Memo to Mr. W. H. Holmes  
Meiners Oaks Dam No. 768  
Inspections of Construction  
By J. V. Spielman

Meiners Oaks Dam No. 768

Meiners Oaks Dam No. 768

Review of Plans

# Field Data

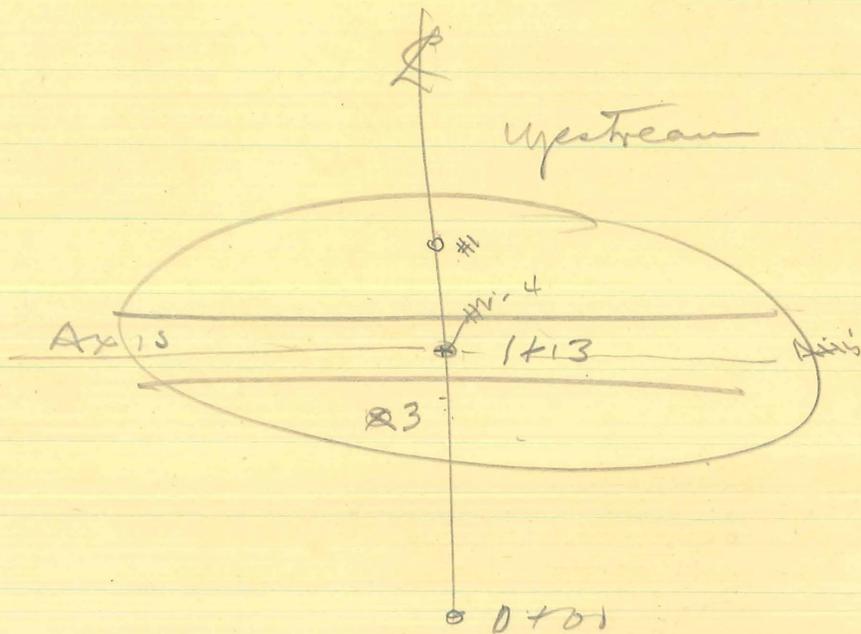
1	7/14/50	1+45 on E	Mid pt of upper fill.	108.0	9.57
2	7/14/50			107.5	5.5
3	7/18	0+95		105.0	9.25
4	7/18			122.0?	9.8

Soil Compaction  
Test by JVS  
7/18/50

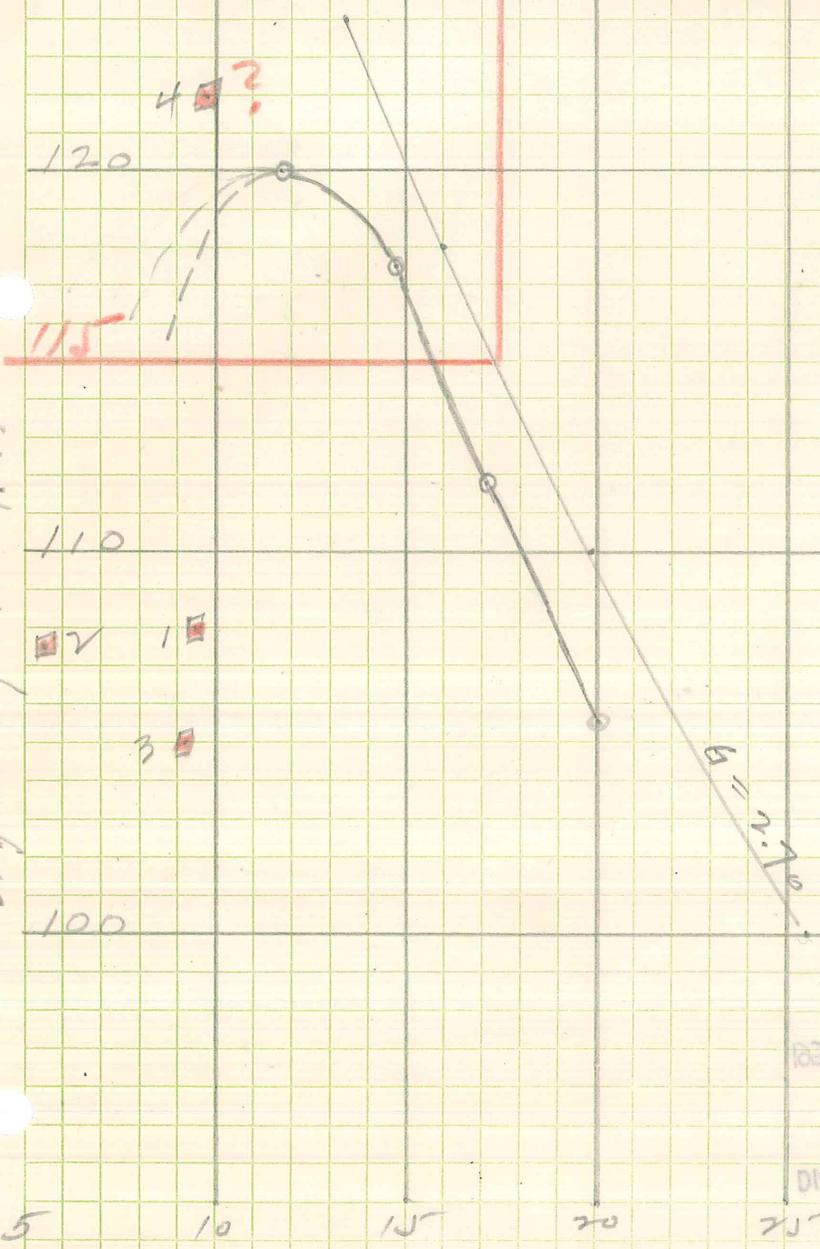
Only two density tests had been recorded showing field densities of 108 and 107.5 p.c.f. although the specifications called for 119 p.c.f. Mr. Dron gave the writer the attached laboratory compaction test sheet on samples 3 and 4 made by Walter Loban. Sample 3 is apparently the material principally being used. Sample 4, according to Mr. Dron, is a very fine clayey silt which he thought suitable for the impervious section. Some of it may be getting mixed with the sandy soil. From Loban's test it would appear not to be a suitable soil. Mr. Loban's needle curve for sample 3 is an odd shape as was the original test submitted with the application. These tests indicated a required density of 118 or 119 p.c.f. for an I.S.P.R. of 300.

With borrowed equipment the writer proceeded to make a compaction test on the morning of July 18 and Mr. Dron made two more fill density tests. Results are all shown on attached copy of soil compaction test made by the writer.

From this the writer concluded and so stated to Mr. Dron and Mr. Ford that the minimum fill density should be 115 p.c.f. and that all existing fill below that density should be removed. Perhaps 1,000 or 2,000 cu. yds. of fill will need to be removed and recompacted. The writer also discussed with Mr. Dron that he should keep an inspector on the fill at all times, that

density tests should be made at least once a day and better procedure to obtain greater accuracy in the test. The writer also insisted that rollers meeting the weight specification be obtained. Mr. Dron gave orders to the contractor to comply with the specifications.
